North Dakota Department of Transportation

PLAN REVISION PROJECT NO. F-RRS-1-006(005)066

PLAN and/or CONTRACT REVISION

PROJECT NO.: F-RRS-1-006(005)066
 COUNTY: Morton
 CONTRACTOR: Northern Improvement
 DATE: January 18, 1991

TRAFFIC CONTROL SYSTEM

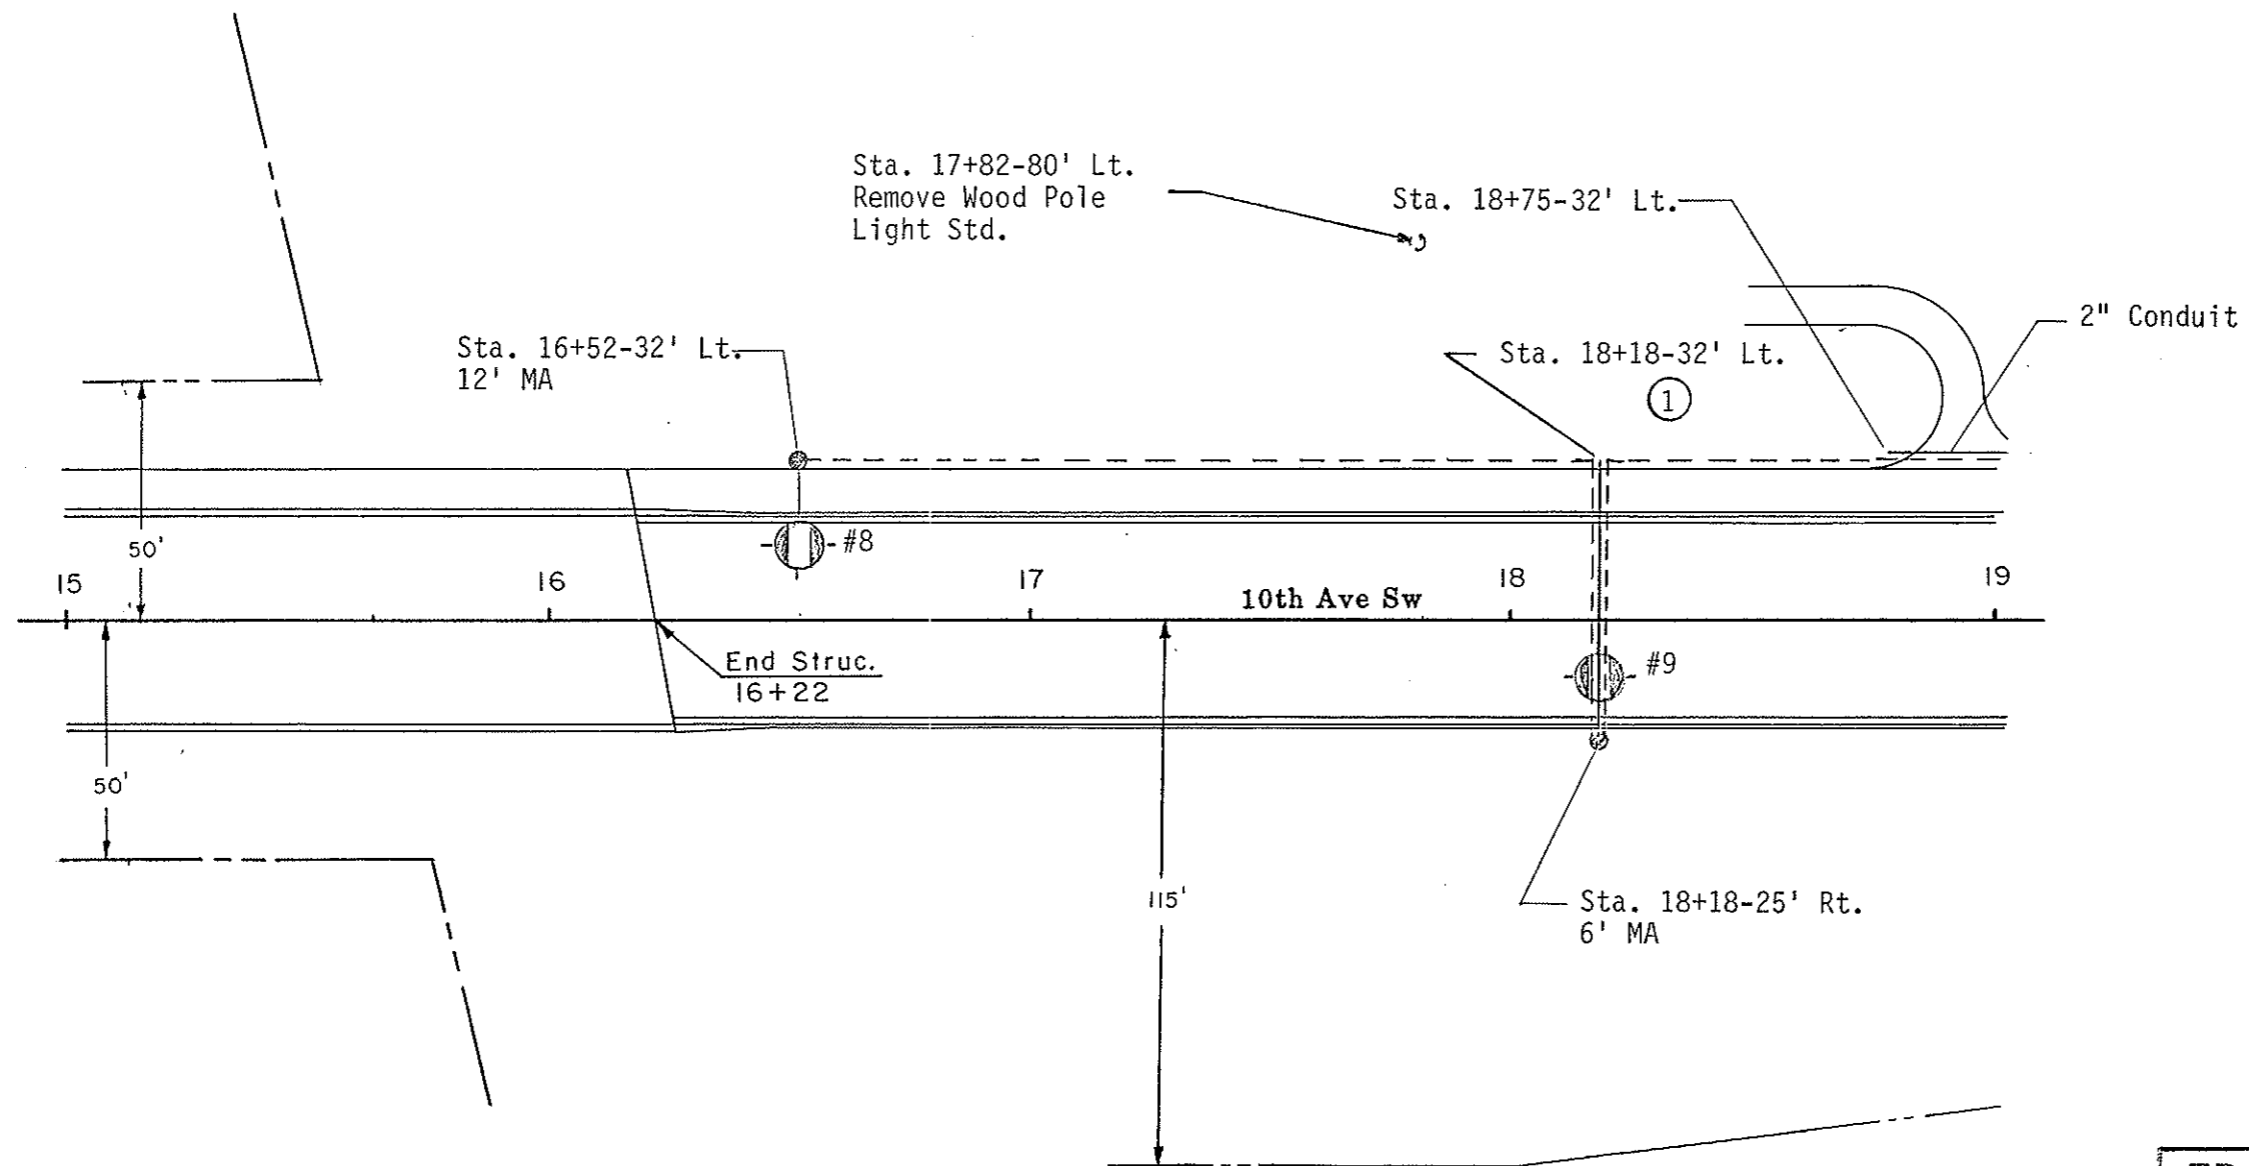
Sheet 109: Revised conductor and conduit runs to light standard #9.

Sheet 109: Revised conductor and conduit runs to light standard #9.

TRAFFIC CONTROL SYSTEM
 Lighting Layout
 Sta. 19+00-23+00

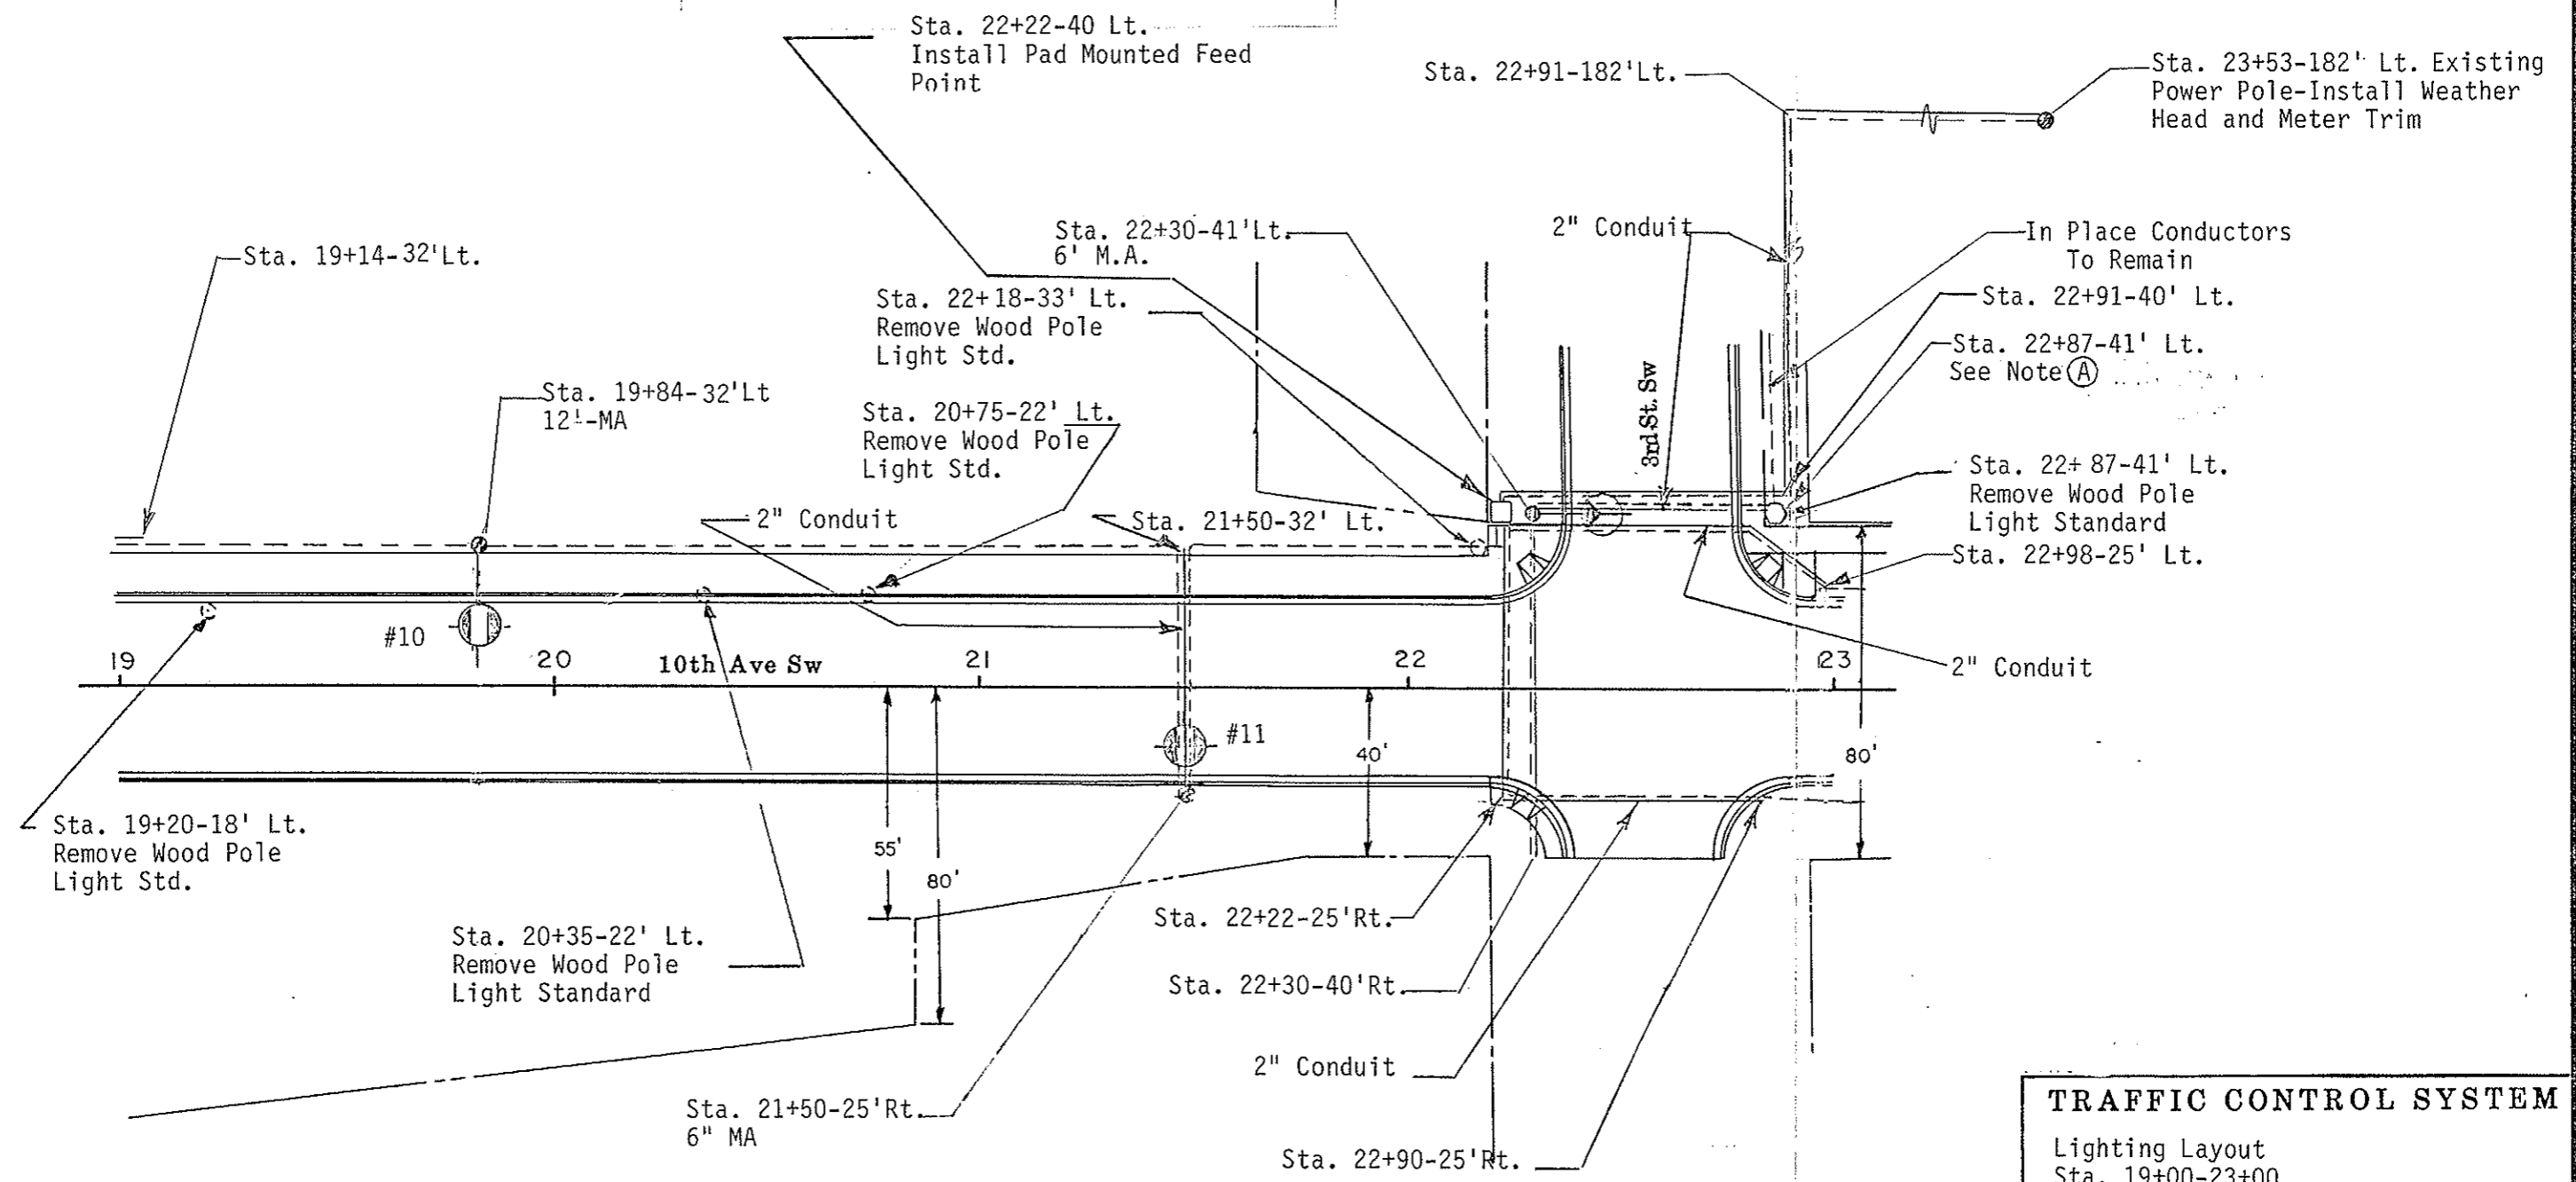
Sheet 123: Moved feed point from station 22+91-38' Rt. to station 22+22-40' Lt. and revised conduit and conductor runs.

Sheet 123: Moved feed point from station 22+91-38' Rt. to station 22+22-40' Lt. and revised conduit and conductor runs.

NOTE (A) The contractor shall locate and splice the in place conductors to provide continuity. The splice shall be waterproof and approved by the Engineer. The contractor shall be responsible for any damage to the existing underground conductor and shall replace any damaged conductor at his own expense.

TRAFFIC CONTROL SYSTEM
 Lighting Layout
 Sta. 43+00 - 48+31

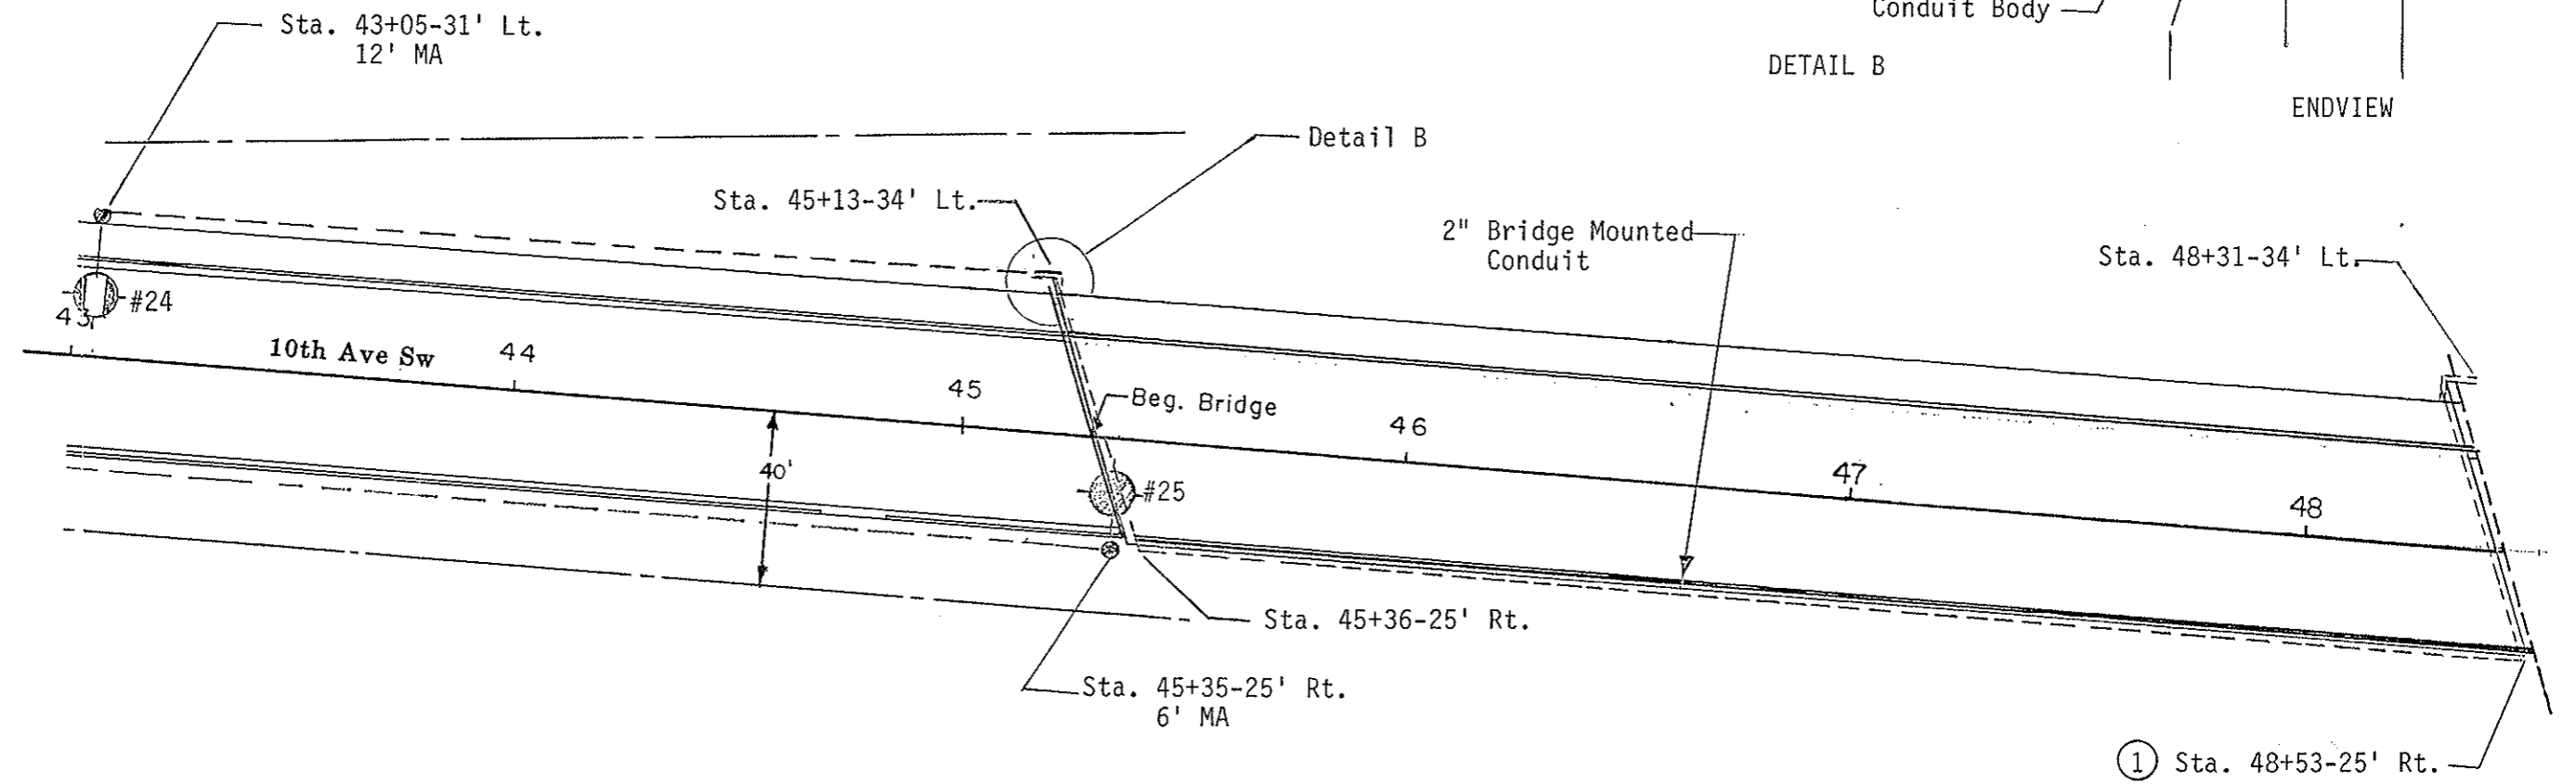
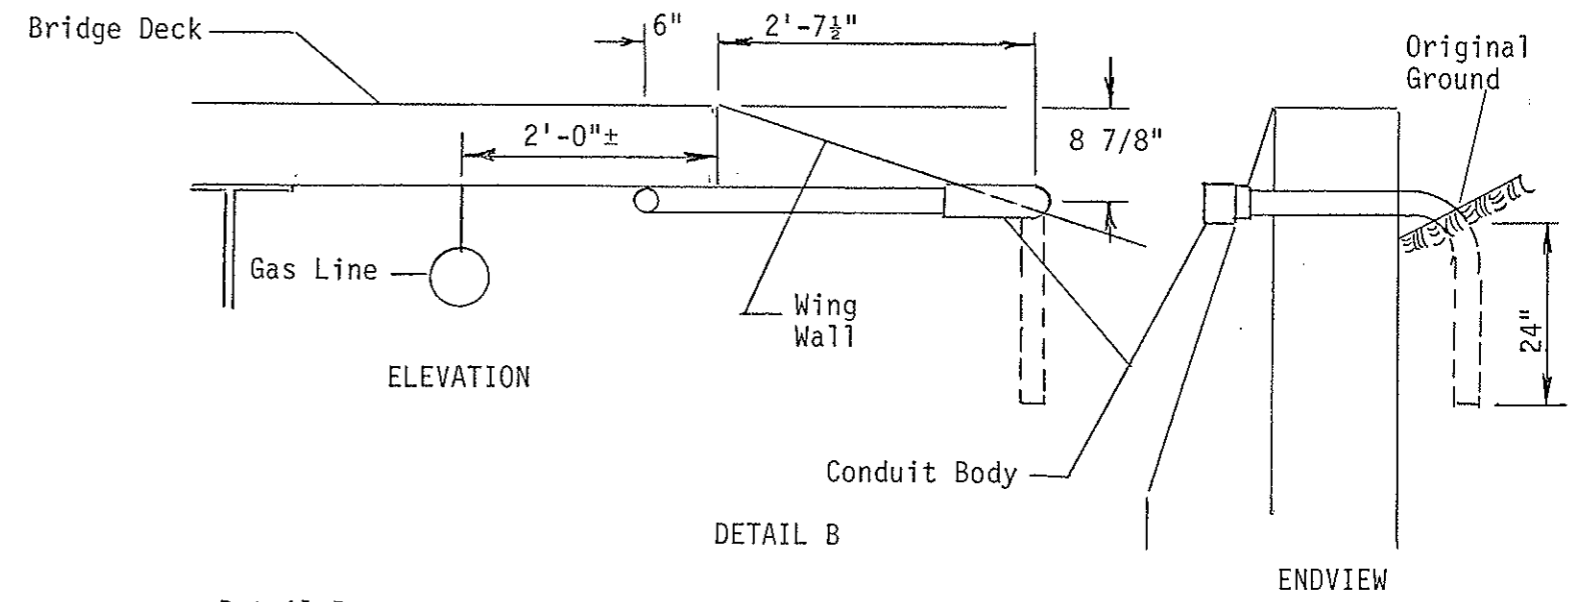
Sheet 139: Moved conduit and conductor from the east side of the bridge to the west side of the bridge.

Sheet 139: Moved conduit and conductor from the east side of the bridge to the west side of the bridge.
